Project Name McDuffie Terminal Dock 2 Refurbishment – Supply of Rail and Associated Components

ADDENDUM NO. 1

Item	Description
NOTES	
1	Contractor Questions
2	Revised Drawing 4732-S2 Rev. B

McDUFFIE TERMINAL – DOCK II REFURBISHMENT
SUPPLY OF RAIL AND ASSOCIATED COMPONENTS
RAIL REPLACEMENT – PLAN & DETAILS

PROJECT NO: 4732 DWG NO: S2 REV: B

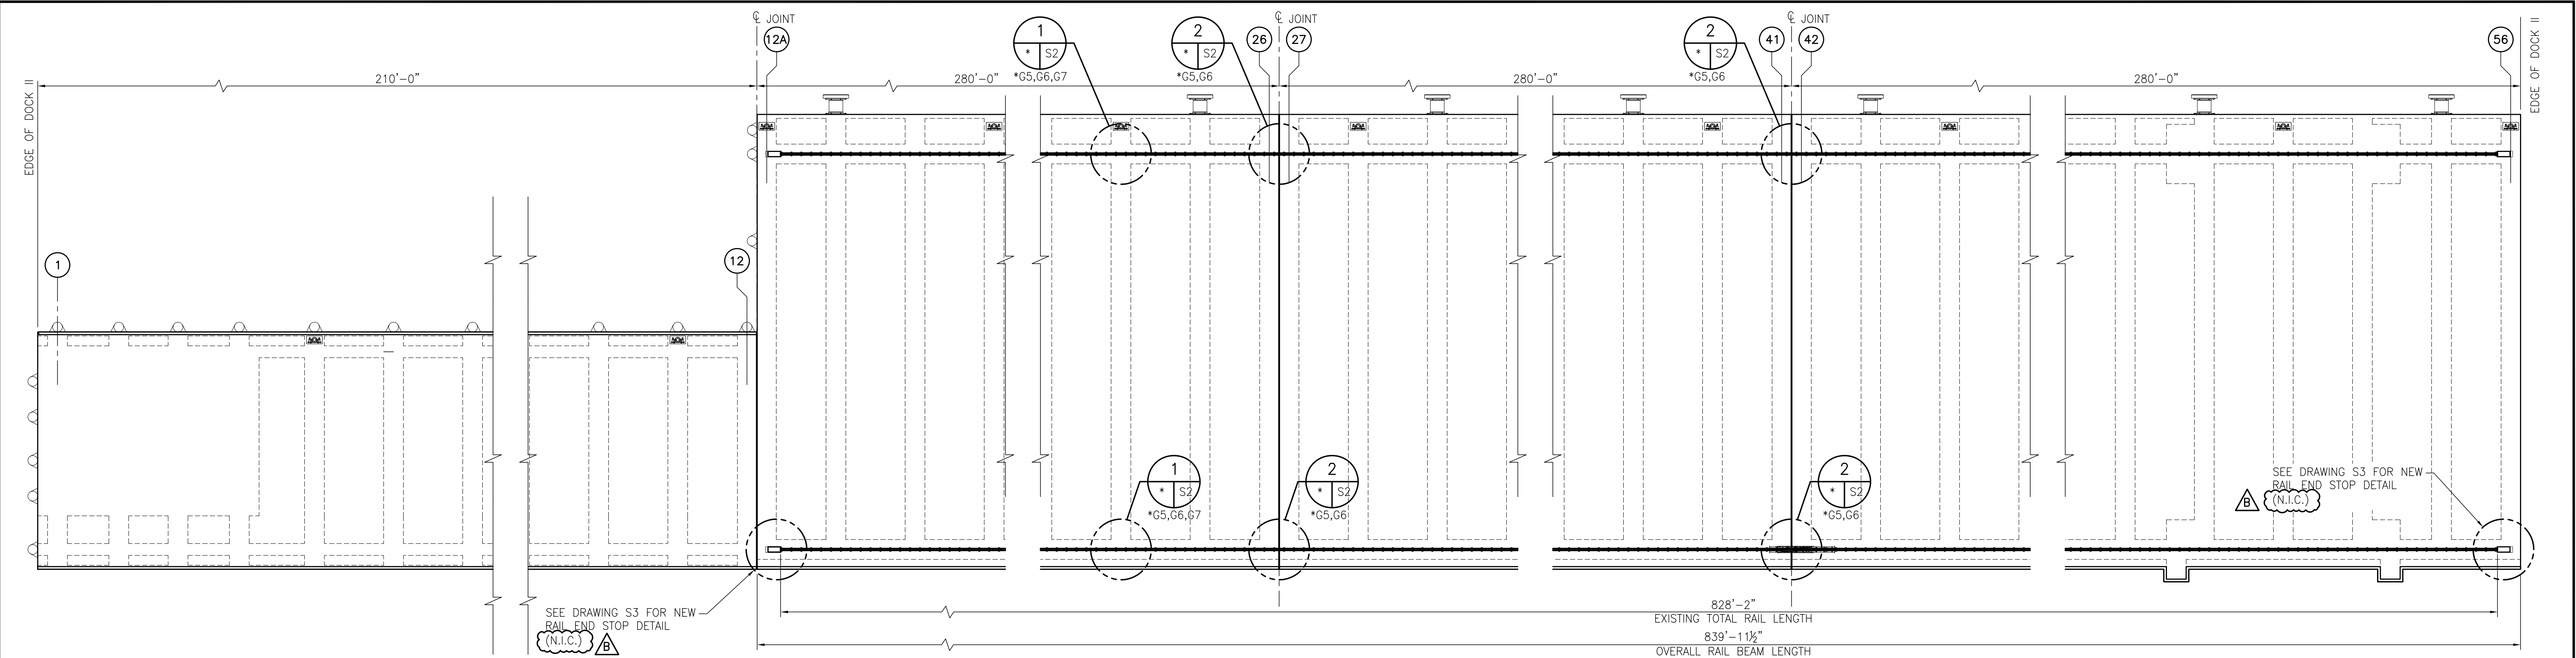
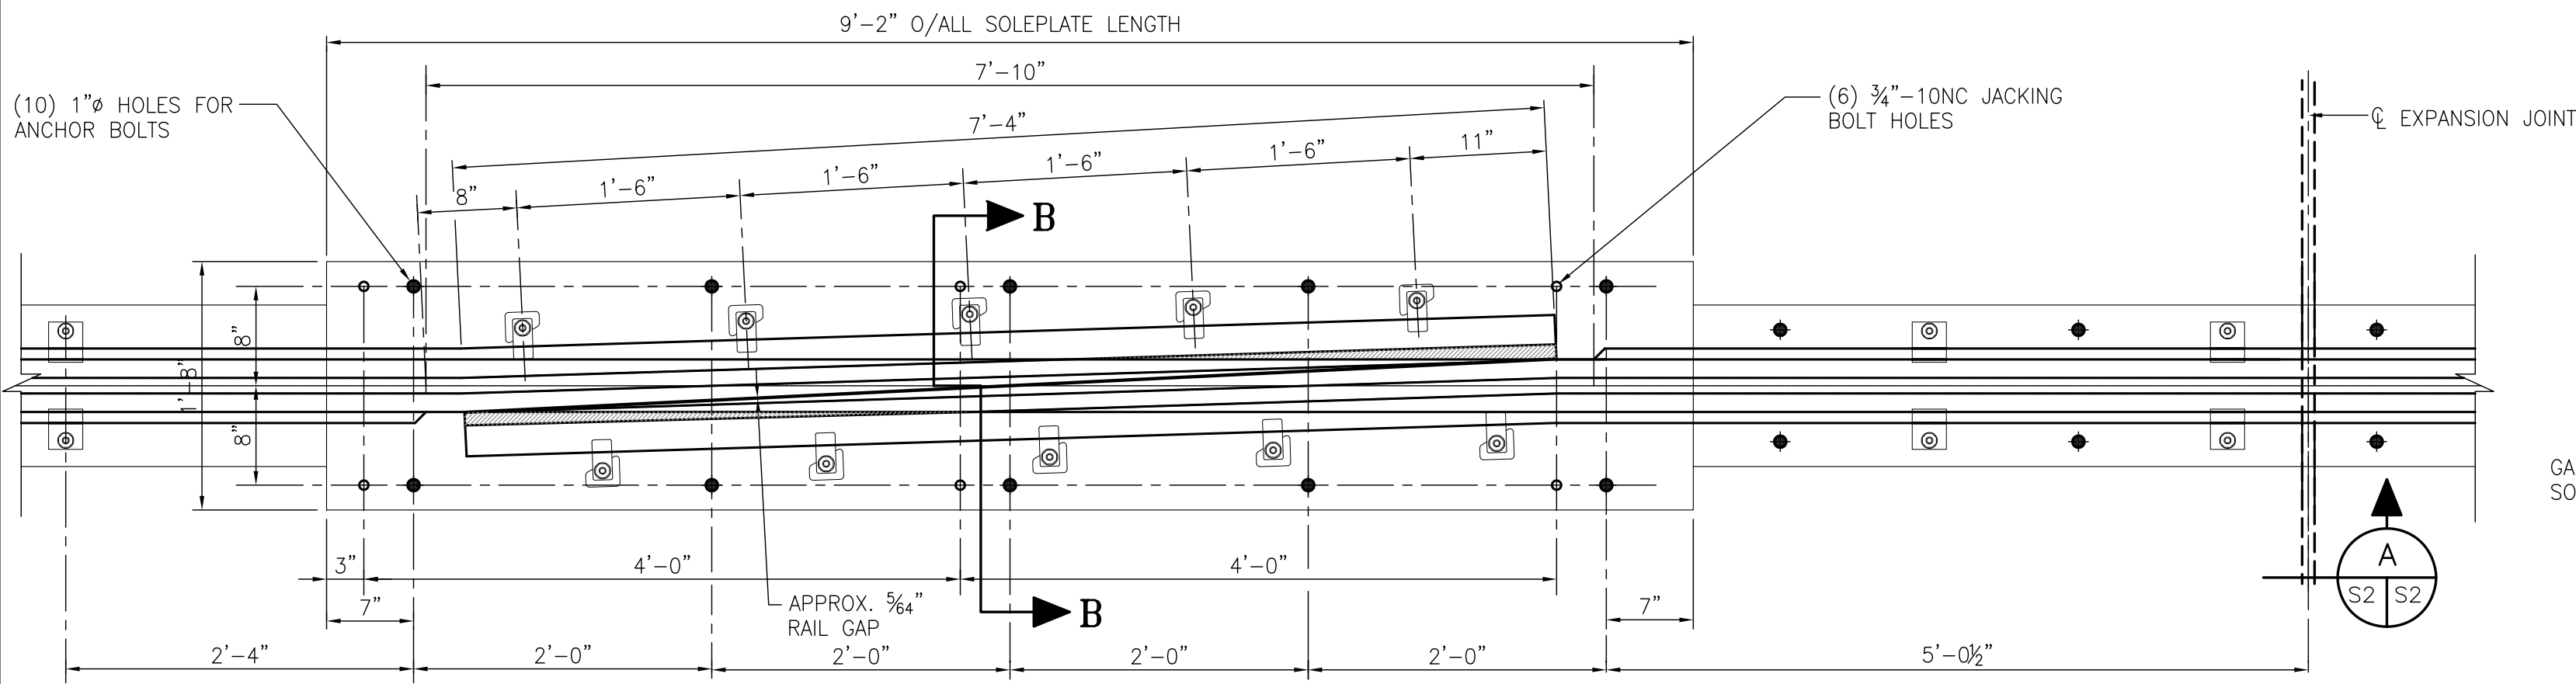
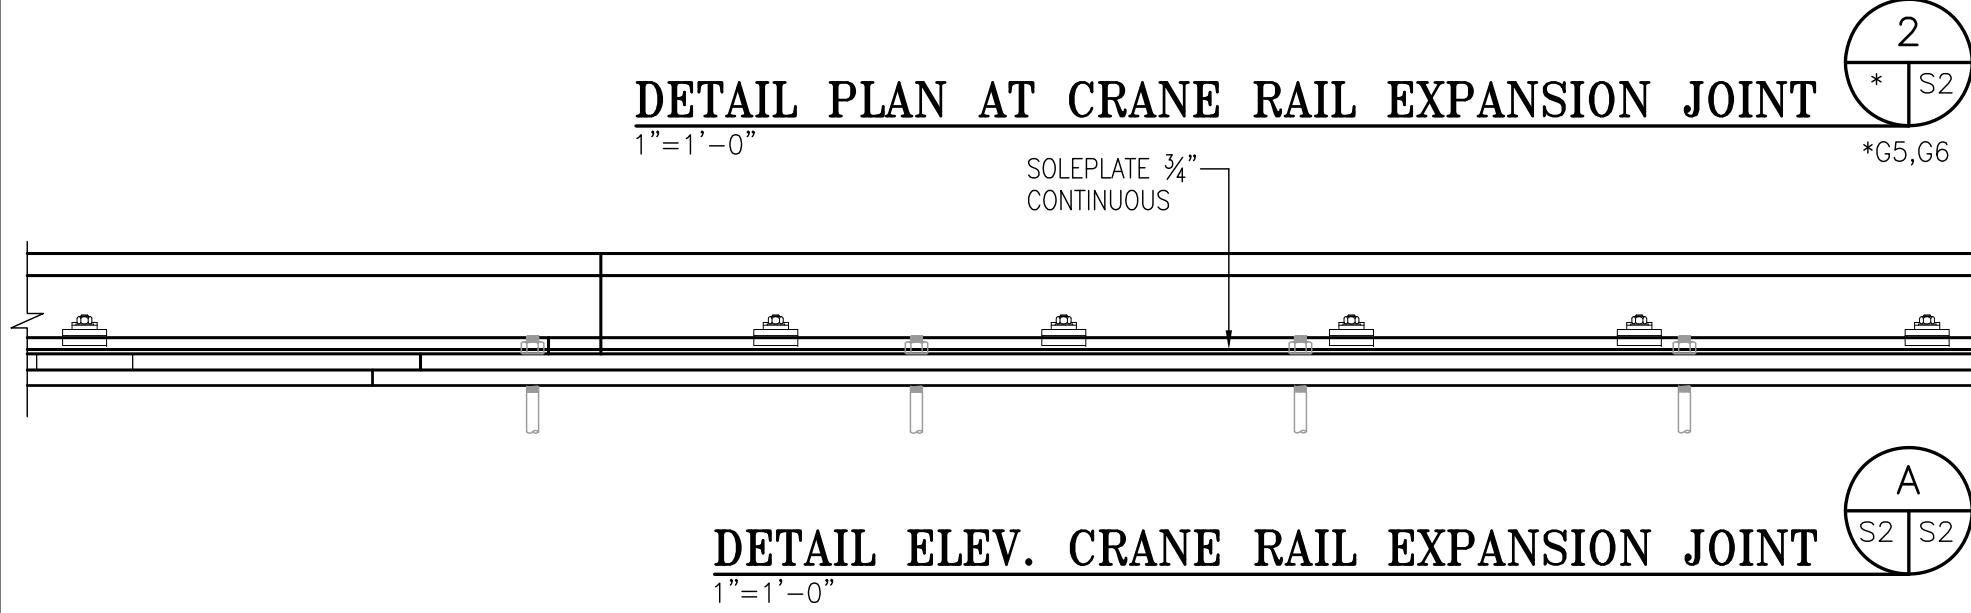
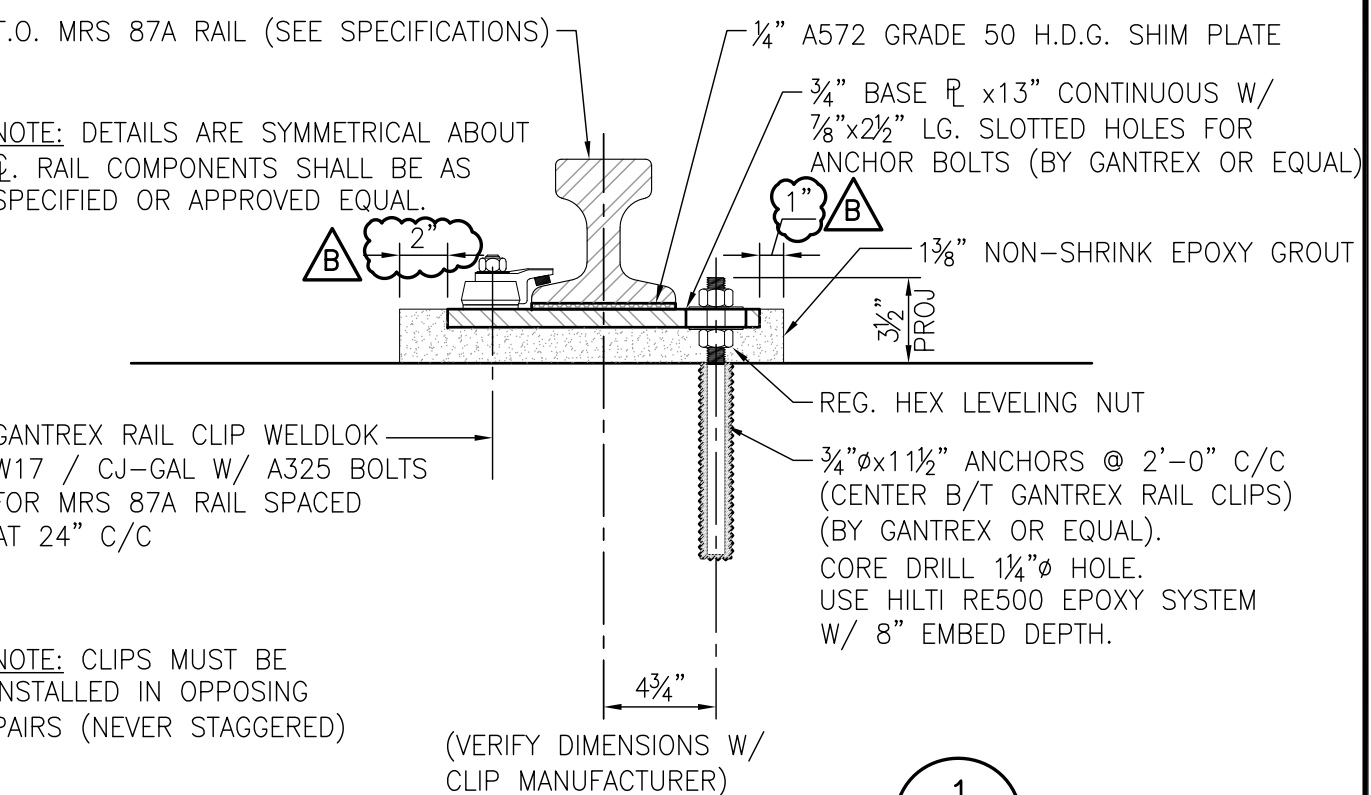
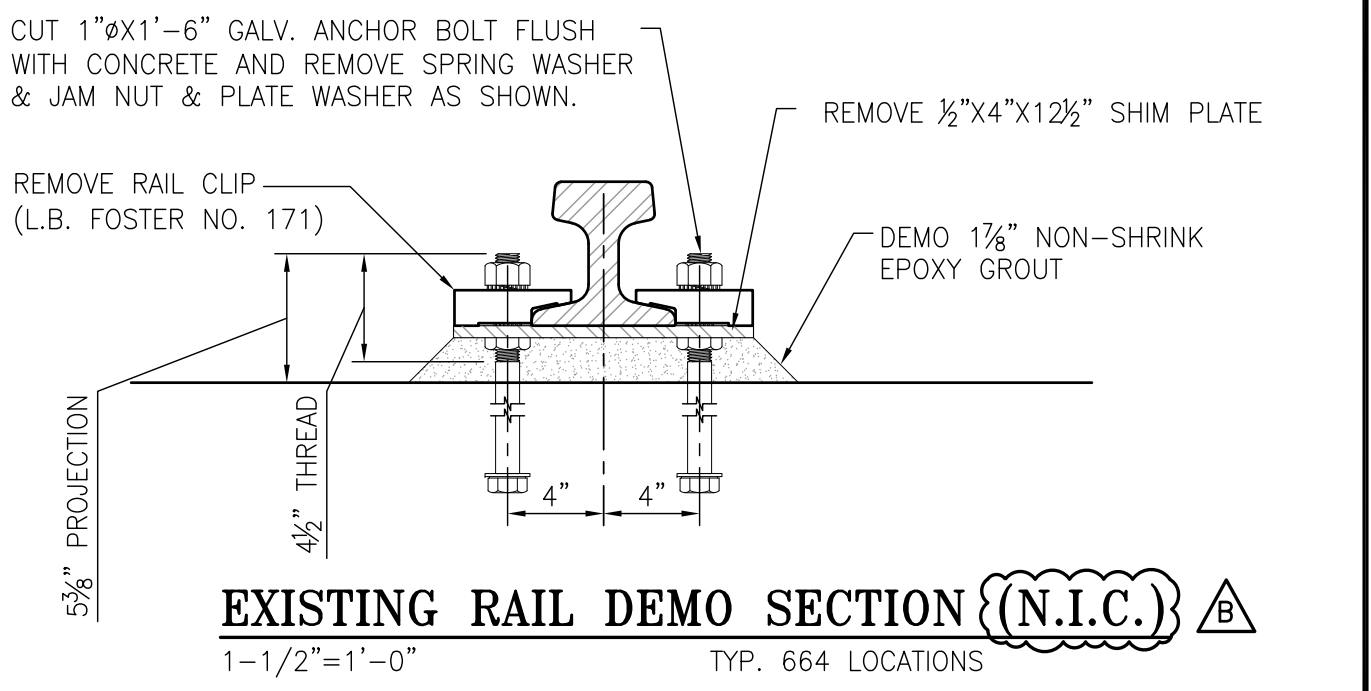
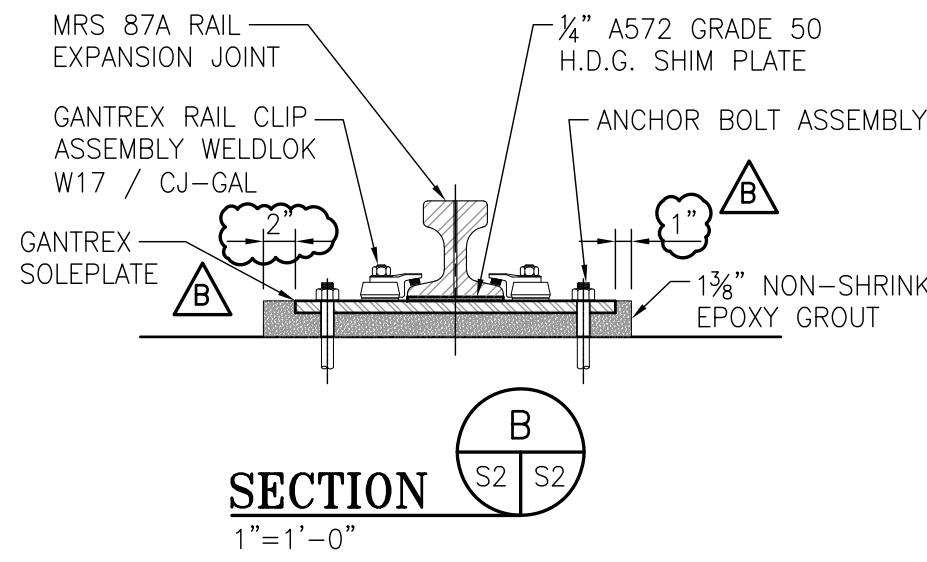
- Head hardened statement is removed from the requirements.
2. Can you please confirm that the use of Jacking Bolts can be used on all of the Typical Support Plates? Drawing S2, Rail Installation Detail shows a Leveling Nut being used.

- Jacking bolts can be used
3. Drawing S2 indicates in the Plan View to review Crane Stop Detail on S3. Is this relevant for this project or No?
 - No. Not relevant to this project

4. For the Anchor Bolts, Drawing S2 indicates that the Anchor Rods will be Core Drilled. With that being said, we will submit with our quote the Ultrabond HS-1CC Anchor Gel (Data Sheet attached).

- Ultrabond HS-1CC anchor gel is acceptable
5. For clarity, The drawing states that the rail is to be thermite welded but the specifications indicate that Thermite or Flash Welding are to be used.

- Drawing note is revised for either Thermite or Flash Butt Welding
6. For epoxy grout, we would need a head box and an additional 3” of grout beneath the sole plate, 2” on 1 side for hydrostatic head pressure and 1” on the opposite side for air release.

- Drawing detail is revised for epoxy grout installation

NOTES	
ALL CRANE RAIL SHALL BE THERMITE OR FLASH BUTT WELDED.
